Contract #: 04-0120F4Cty: SF/ALA Rte: 80 PM: 13.2/13.9File #: 69.25B**QUALITY ASSURANCE -- NON-CONFORMANCE REPORT****Location:** Changxing Island, Shanghai, P.R. China**Report No:** NCR-000862**Prime Contractor:** American Bridge/Fluor Enterprises, a JV**Date:** 13-Oct-2010**Submitting Contractor:** Zhenhua Port Machinery Company, Ltd (ZPMC), Changxing Island**NCR #:** ZPMC-0824**Type of problem:**

Reference Description: Missed UT Indication: West Lift 5 Grillage Plate**Description of Non-Conformance:**

Job Name: SAS Superstructure

Subject: NCR No. ZPMC-0824

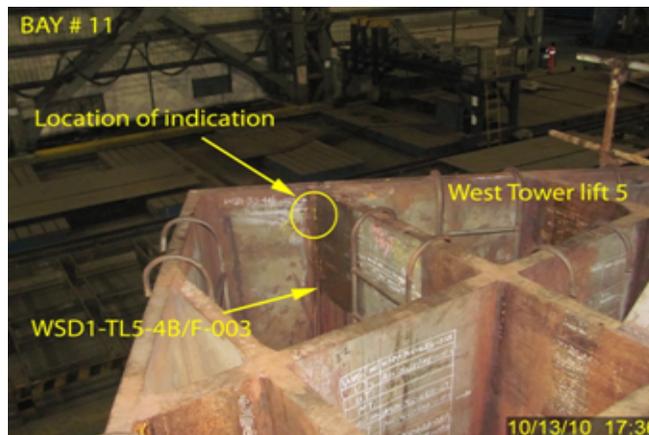
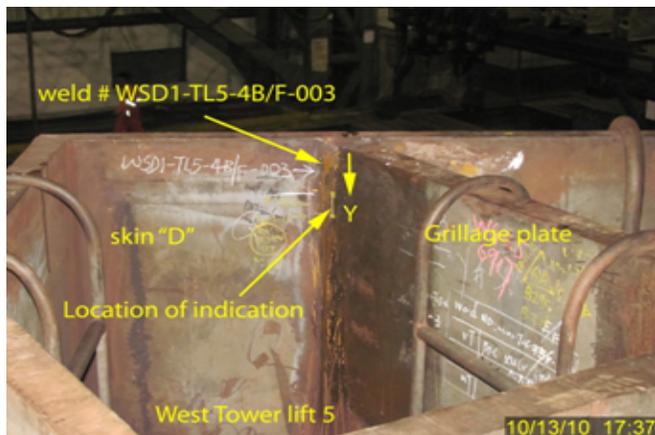
During the Quality Assurance Ultrasonic Testing (UT) verification of welds located on grillage plate of West Tower lift 5, this Quality Assurance (QA) Inspector discovered the following issues:

- One class "A" longitudinal indication measuring approximately 50mm in length.
- The depth of the indication is 57mm.
- The db rating is -2.
- The material thickness is 65mm.
- The weld is identified as: WSD1-TL5-4B/F-003.
- The Weld is a Complete Joint Penetration (CJP) with steel backing, T-joint, joining the grillage plate to the skin plate (skin "D").
- The "Y" location of the indication is 110mm from top side
- The indication is clearly marked on the component.
- The member is located in Bay 11.

The Notice of Witness Inspection Number (NWIT) is 06938. The indication is located inside the area that has been previously tested and accepted by ZPMC Quality Control (QC) personnel. As per the contract documents, ZPMC's QC personnel are required to perform 100% UT inspection of this weld.

- Attached photographs provide additional location details.

This proposed resolution is acceptable. The documentation received is sufficient and the Department concurs that Non-Conformance ZPMC-0824 is closed.

Reference Description: QA found UT indications on Segment 13 LD after ZPMC had tested and accepted the welds

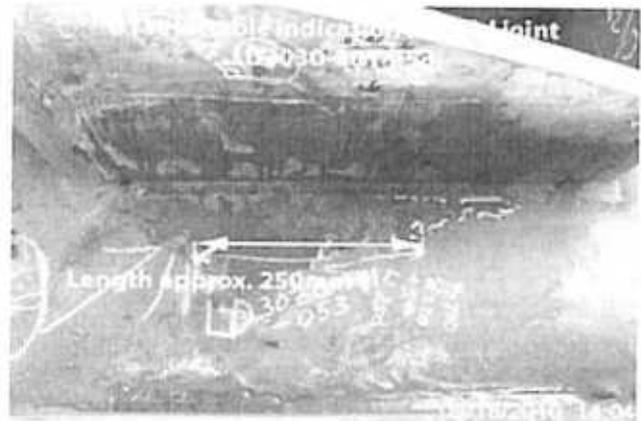
During the Quality Assurance (QA) Ultrasonic Testing (UT) review of welds located on Orthotropic Box Girder (OBG) segment 13BE and 13CE, this QA Inspector discovered the following issues:

- Three (3) longitudinal linear class "A" rejectable indications measuring approximately 180mm~260mm in length.
- The welds are identified as LD3028-001-031, LD3027-001-026 and LD3030-001-053.

- Material thickness for all joints is 30mm.
- The indication db rating for joint LD3028-001-031 is a +6.
- The indication db rating for joint LD3027-001-026 is a +4.

- The indication db rating for joint LD3030-001-053 is a +5.
- The depth of the indications are from 20mm~23mm deep.
- The Weld LD3028-001-031 is joining longitudinal diaphragm (X3682A) to lifting Lug.

These welds were designated to be PJP welds and no UT is required. The NWIT were submitted due to the internal fault between the floor QC & NDT operator of ZPMC. ZPMC is providing the MT records to show the acceptance of these welds and is requesting closure of this NCR.

LONGITUDINAL DIAPHRAGM SUB-ASSY ~ MARK LD3030A
(TYPE 2) (Ø E3, LOOKING NORTH - DEVELOPED)

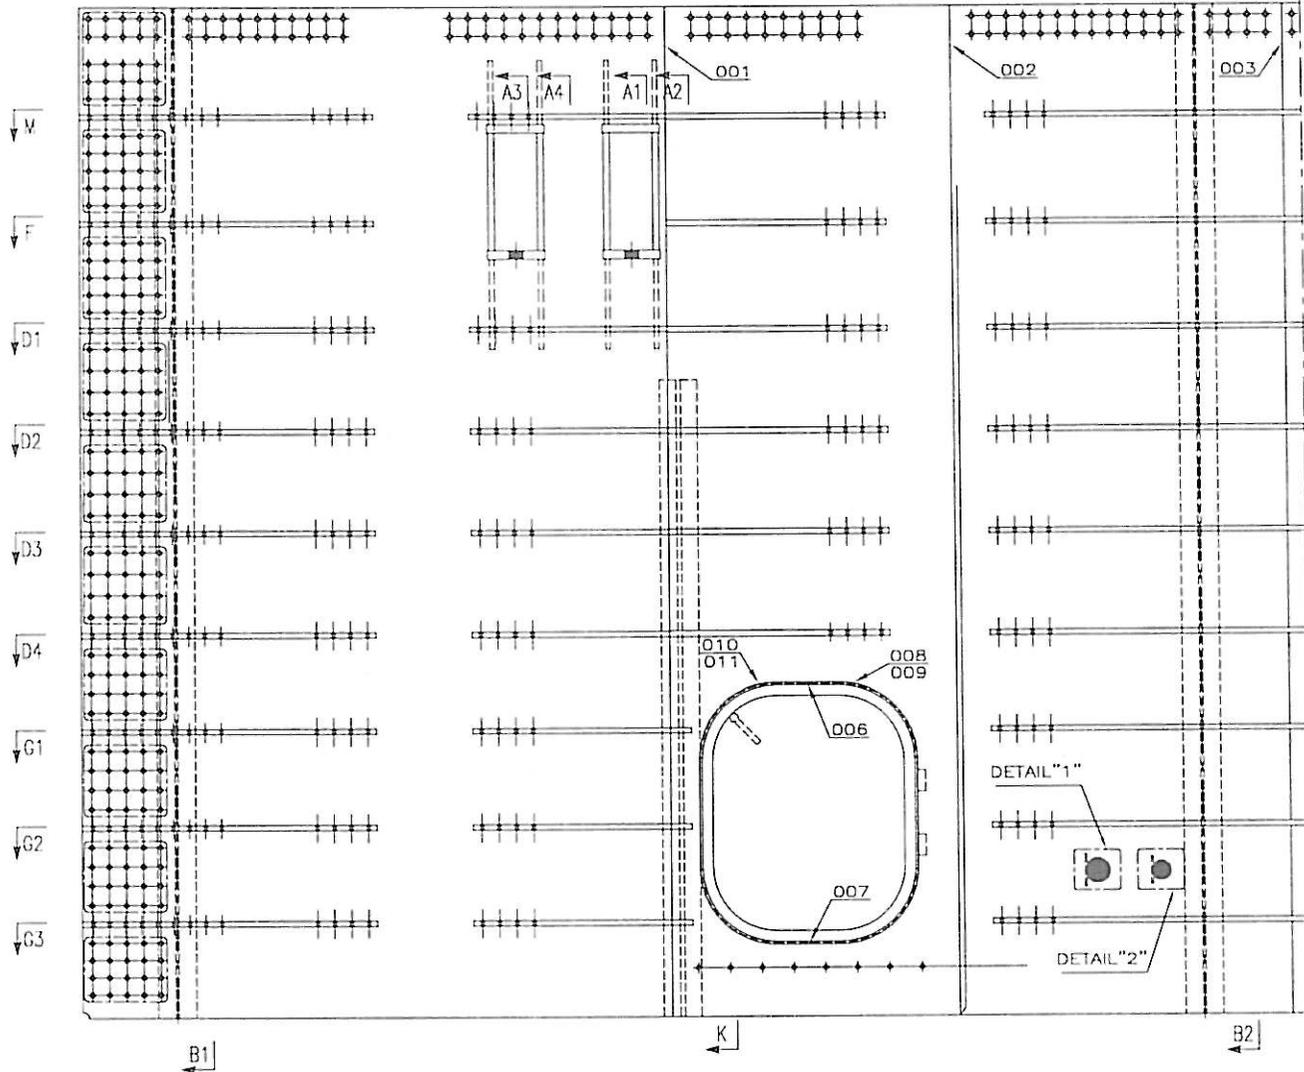
- The Weld LD3027-001-026 is joining longitudinal diaphragm (X3684B) to lifting Lug.
- The Weld LD3030-001-053 is joining longitudinal diaphragm (X3685A) to lifting Lug.

Reference Description: QA found a missed MT transverse crack after ZPMC had tested and accepted the weld in the Bikepath

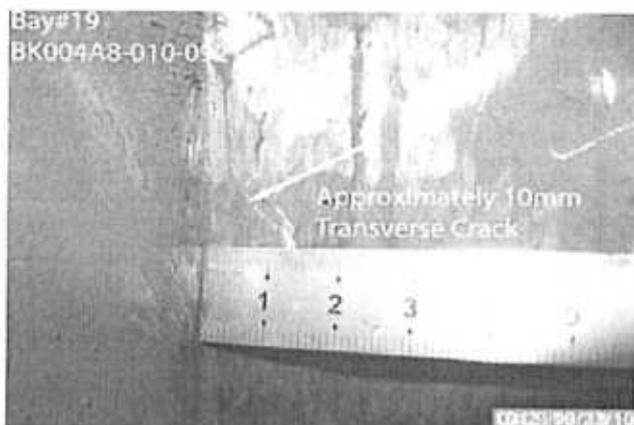
During the Quality Assurance (QA) Magnetic particle Testing (MT) review of welds located on OBG Bike path BK004A-010, this QA Inspector discovered the following issue:

- One transverse crack that measured approximately 10mm in length.
- The weld is identified as BK004A8-010-092.
- The weld is a Partial joint penetration (PJP) T joint, joining the Stringer plate (BKX9C) to the End diaphragm plate (BKX11GA).
- The Y Location is 100mm from the bearing plate.
- The OBG Bike path is located in BAY#19.
- This crack is clearly marked on the material on/near the weld.
- This weld joint is designated as Non-Seismic performance critical (Non-SPCM) weld member.
- The Notice of Witness Inspection Number (NWIT) is 006731.
- The crack is located within the area that has been re-tested and accepted by ZPMC Quality Control (QC) subsequent to the heat straightening procedure.

ZPMC acknowledged the indication was missed and has issued an internal NCR to address this problem. ZPMC has repaired the indication and is providing the NDT record to show the acceptance of this weld. Based on this, ZPMC is requesting closure of this NCR.

Reference Description: QA found a missed MT transverse crack and MT longitudinal crack after ZPMC had tested and accepted the welds in Bikepath Assembly

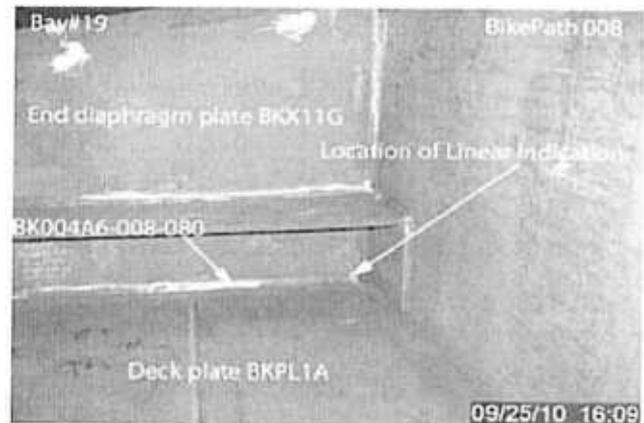
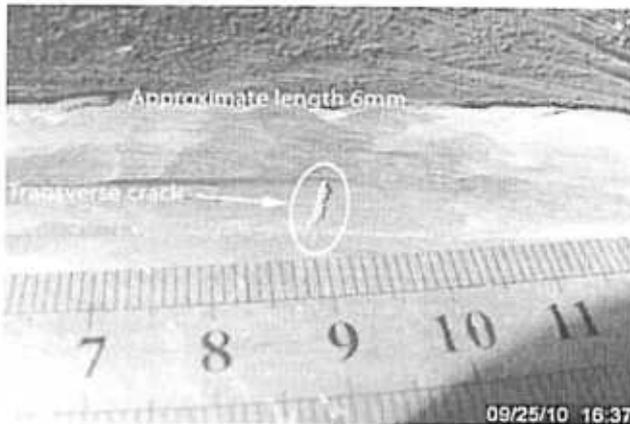
During the Quality Assurance (QA) Magnetic Particle Testing (MT) review of welds located on Bike Path 008, this QA Inspector discovered the following issues:

- One Longitudinal linear crack in the weld measuring approximately 15mm in length.
- The weld is identified as BK004A6-008-080.
- The weld is partial joint penetration (PJP), joining the End Diaphragm plate identified as BKX11G to the Deck Plate identified as BKPL1A.
- This weld joint is designated as Non-Seismic performance critical (Non-SPCM) weld member.
- The crack is clearly marked on the material near the weld.
- The OBG Bike Path 008 is located in Bay #19.

Quality Assurance (QA) Magnetic Particle Testing (MT) review of fillet welds located on OBG bike path BK004A-018, this QA Inspector discovered the following issues:

- One (1) transverse crack found on the weld measuring approximately 6mm in length.
- Y location of the indication is measured to be 2160mm.
- The crack is clearly marked on the weld joint.
- The weld is identified as: BK004A3-018-052.
- The Weld is a fillet weld joining the stringer plate (8C) to the deck plate of bike path.
- The member is located in bay 11.

ZPMC acknowledged the indications were missed and has issued an internal NCR to address this problem. ZPMC has repaired the indications and is providing the NDT records to show the acceptance of the welds. Based on this, ZPMC is requesting closure of this NCR.

Reference Description: Lift 5 West Shaft: Missed MT Crack at Skin D and Transverse Plate

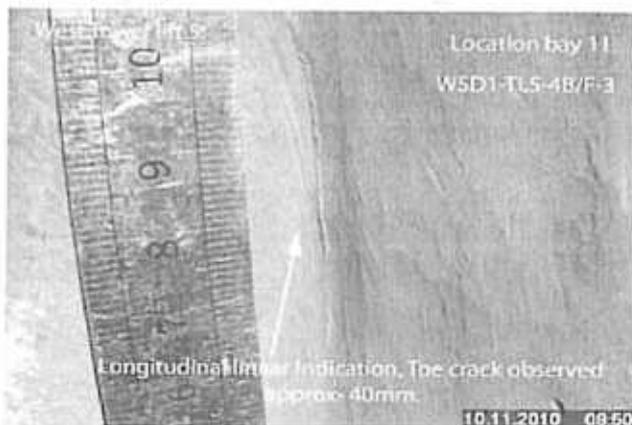
During the Quality Assurance (QA) Magnetic Particle Testing (MT) review of welds located in West Tower lift 5 Grillage plate, WSD1-TL5-4B/F-3, this Quality Assurance (QA) Inspector discovered the following issues:

-One longitudinal toe crack measuring approximately 40mm in length.

-The weld is identified as: WSD1-TL5-4B/F-3.

-The Weld is a Complete Joint Penetration (CJP) weld, joining the grillage plate to skin plate.

-The Notice of Witness Inspection Number (NWIT) is 06917. The indication is located on CJP weld area that has been previously tested and accepted by ZPMC Quality Control (QC) personnel. As per the contract documents, ZPMC's QC personnel are required to perform 100% MT inspection of this weld. The attached photographs provide additional detail.

ZPMC acknowledged the indication was missed and has issued an internal NCR to address this problem. ZPMC has repaired the indication and is providing the NDT record to show the acceptance of this weld. Based on this, ZPMC is requesting closure of this NCR.

Reference Description: Missed UT Indication: West Lift 5 Grillage Plate

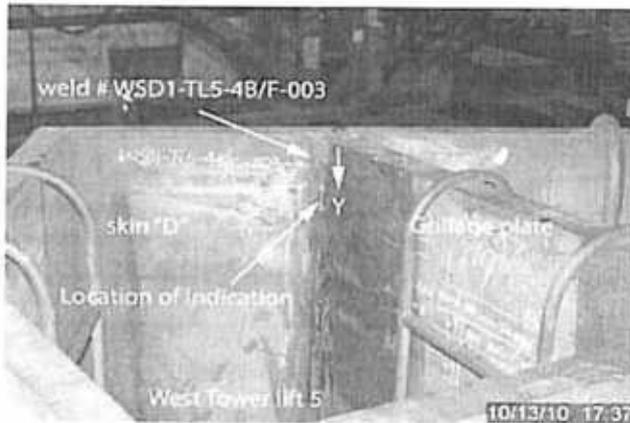
During the Quality Assurance Ultrasonic Testing (UT) verification of welds located on grillage plate of West Tower lift 5, this Quality Assurance (QA) Inspector discovered the following issues:

- One class "A" longitudinal indication measuring approximately 50mm in length.
- The depth of the indication is 57mm.
- The db rating is -2.
- The material thickness is 65mm.
- The weld is identified as: WSD1-TL5-4B/F-003.
- The Weld is a Complete Joint Penetration (CJP) with steel backing, T-joint, joining the grillage plate to the skin plate (skin "D").
- The "Y" location of the indication is 110mm from top side
- The indication is clearly marked on the component.
- The member is located in Bay 11.

The Notice of Witness Inspection Number (NWIT) is 06938. The indication is located inside the area that has been previously tested and accepted by ZPMC Quality Control (QC) personnel. As per the contract documents, ZPMC's QC personnel are required to perform 100% UT inspection of this weld.

-Attached photographs provide additional location details.

ZPMC acknowledged the indication was missed and has issued an internal NCR to address this problem. ZPMC has repaired the indication and is providing the NDT record to show the acceptance of this weld. Based on this, ZPMC is requesting closure of this NCR.

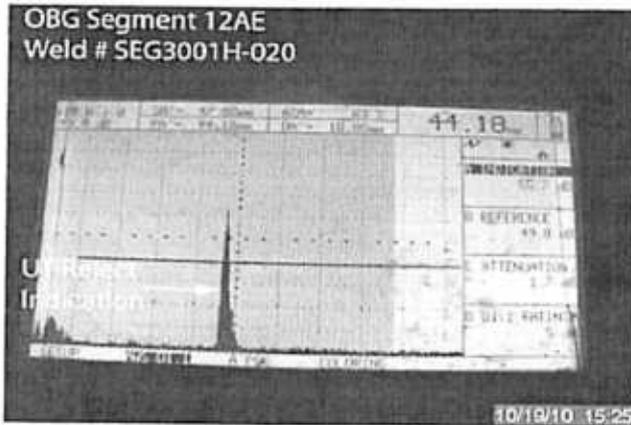
During the Quality Assurance (QA) Ultrasonic Testing (UT) verification of weld located on Segment 12AE, this QA Inspector discovered the following issue:
